From: Steven Fairchild, HP (steve.fairchild@hp.com)
 Date: 27 January 2005
 Subject: SAS 1.1 External Connector Interoperability

Figure 1, Plugfest Configuration

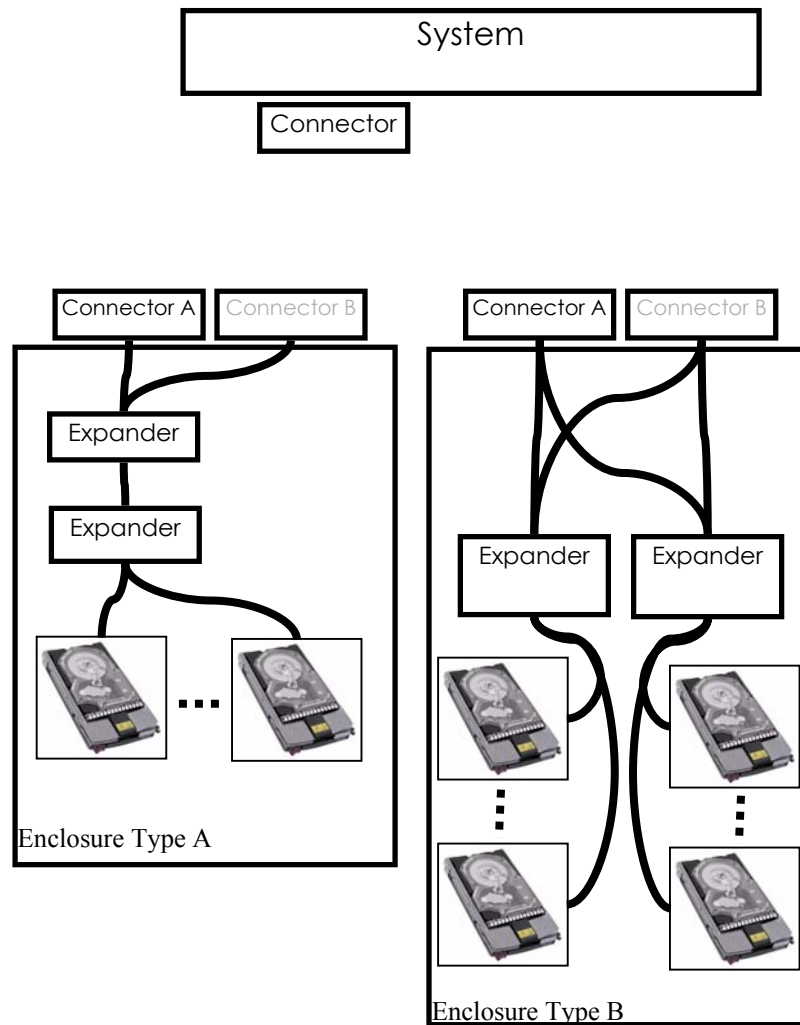
The first issue is an incompatibility that is created when phys routed to an external connector are attached to different expander and/or end devices within the enclosure (see Figure 1).

When the System connector was attached to either of the enclosures (from different manufacturers) the devices were properly discovered. Both enclosures were designed to be “daisy chained” to additional enclosures. When enclosures from the same manufacturer were

“daisy chained” (Enclosure type A to Enclosure type A or Enclosure type B to Enclosure type B) the topology was properly discovered. However when enclosures were “daisy chained” to each other (Enclosure Type A to Enclosure Type B or Enclosure Type B to Enclosure Type A) the topology was not properly discovered.

For “daisy chaining” to function, both enclosures defined one connector (assume Connector A for both enclosures) to use Table routing for the phys in the connector and one connector (assume Connector B for both enclosures) to use Subtractive routing for the phys in the connector. This allows the normal SAS routing behavior of chaining Table to Subtractive to create a large expander device set.

Enclosure Type A chose to attach all of the phys within each of its connectors to a single expander. Enclosure Type B chose to attach the phys within each of its connectors to multiple expanders. These two design choices are what caused the interoperability problem. When Enclosure Type A, Connector B is attached to Enclosure Type B, Connector A (Subtractive phys of Enclosure A to Table phys of Enclosure B) a conflict occurs because the expander attached to Enclosure Type A, Connector B has to different SAS Addresses attached to its Subtractive phys. This is an illegal routing configuration, because the expander attached to Enclosure Type A, Connector B cannot determine where to route its Subtractive addresses. Similar routing issues result from the different connection combinations (see Table 1).

From Table 1, the only legal connection Enclosure A, Connector A attached to Enclosure B, connector B had a problem due to a design decision based on the assumption that a connector would only present a single SAS address if it was attached to an expander.

To resolve this interoperability issue, HP would propose the following text (in blue) be incorporated in SAS 1.1;

The pins of an external receptacle connector may be attached to only one expander device (see 4.1.5), with the phys attached to the pins representing a single expander port (see 4.6.2).

Figure L. 1, SAS Icon for Internal Connections or External Connections to End Devices or External Connection to Expander ports with Subtractive routing attribute

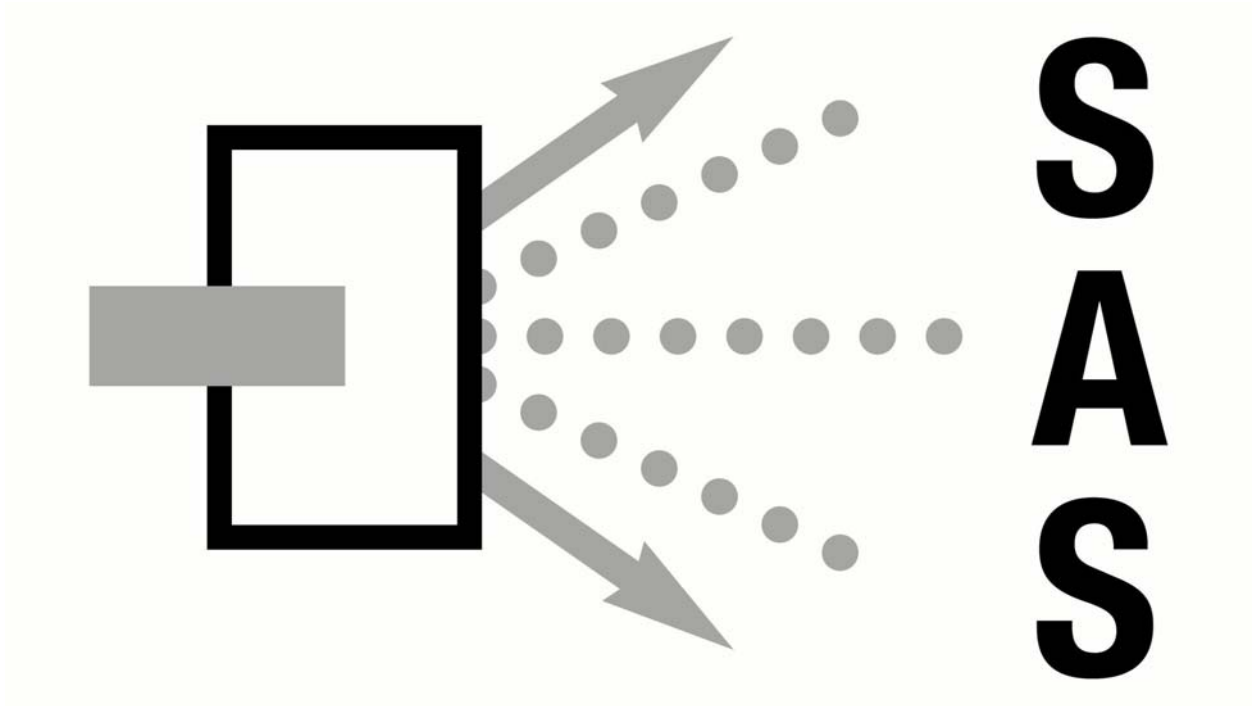
Using Figure 1 to illustrate the problem. During the plugfest there was no standardized way to reference Connector A and Connector B of each Enclosure. There was also no set of guidelines that described connectivity capabilities of an enclosure.

The remainder of this proposal recommends that a naming convention be provided for external connectors (including icons) that provide guidelines for connectivity.

The SAS icons are shown in figure L1 to L2. One of these icons should be located near the external receptacle connector for SAS devices, expander devices or enclosures compliant with this standard.

The icons should be used to describe the connectivity options between external connectors (see Table L.1).
